STATE OF NEW HAMPSHIRE
INTER-DEPARTMENT COMMUNICATION

SUBJECT: Response to Request for More Information
Nashua-Merrimack-Bedford, 13761A
NHDES File Number: 2023-03176

Forwarded herewith is the Response to the NHDES Request for More Information dated February 8, 2024.

TYPICAL CAUSEWAY EMBANKMENT SLOPE

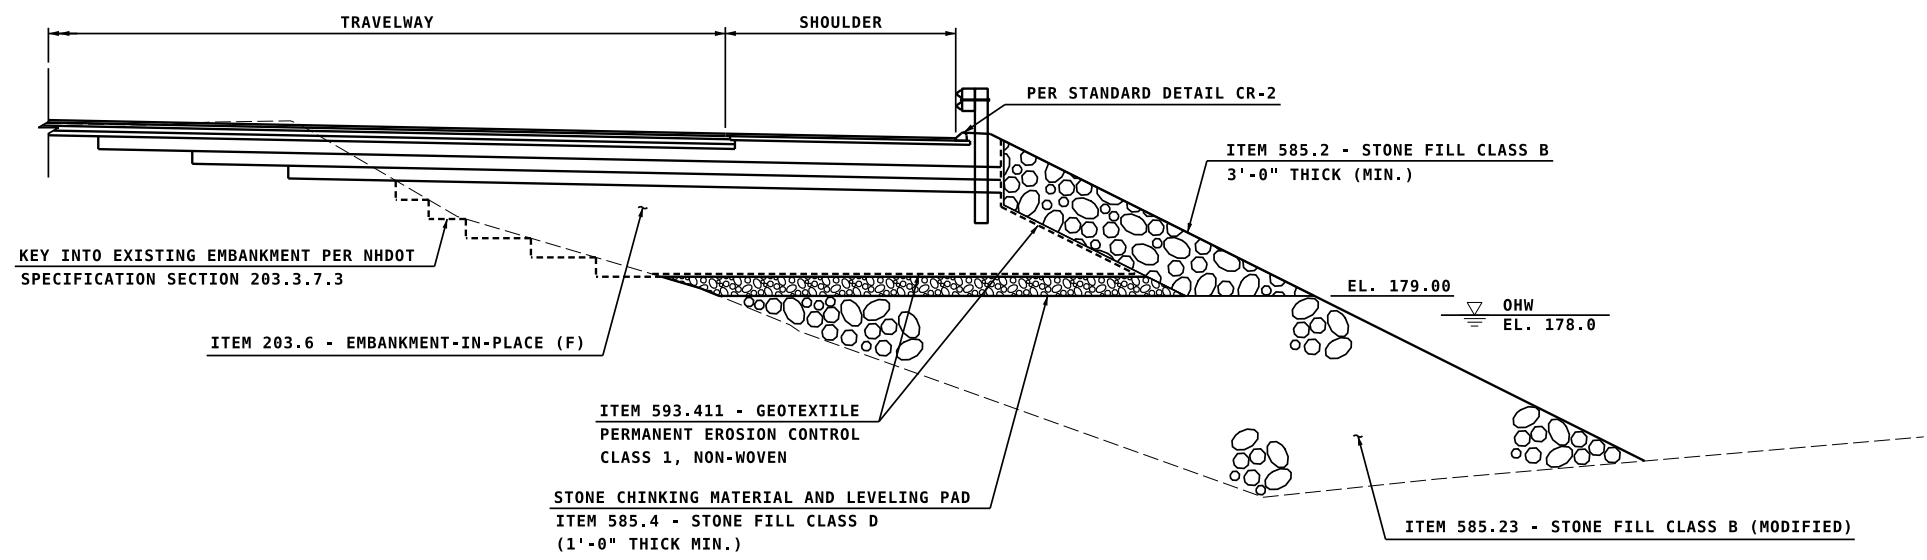
2. Noting that a final clean water bypass and turbidity controls plan would be required as a Condition of any NHDES wetland permit for the project, please identify any available project strategies and specifications related to how turbidity will be managed. Final turbidity control plans would ultimately need to include specific locations of BMPs and implementation of any proposed strategies and specifications for the project.

RESPONSE: Language from the contract documents providing details of the project strategies and turbidity management measures which will be employed during construction has been included below. Please also find the attached SPECIAL PROVISION SECTION 645 -- EROSION CONTROL Item 645.0001 - Turbidity Barrier which provides the specifications related to installation of the turbidity barrier. Please also find the attached causeway fill detail sheet #38 and Bridge Plan sheet # 53 for additional information.

The project includes construction of embankment fill within the existing Pennichuck Brook back-water area approaching the Pennichuck Brook Bridge. This work will include placing Item 585.23 – Stone Fill Class B (Modified) on the bottom of the existing brook up to elevation 179.00 as shown in the plan details. A 12-inch thick lift of Item 585.4 – Stone Fill Class D will be constructed to chink any voids in the

Class B (modified) Stone Fill, Item 593.221 will be placed on top of the Class D Stone Fill prior to having the roadway embankment completed with Item 203.6 – Embankment-In-Place (F). The outer portion of the slopes will use Item 593.411 – Geotextile Non-Woven, and will be covered with 3-feet of Item 585.2 – Stone Fill, Class B.
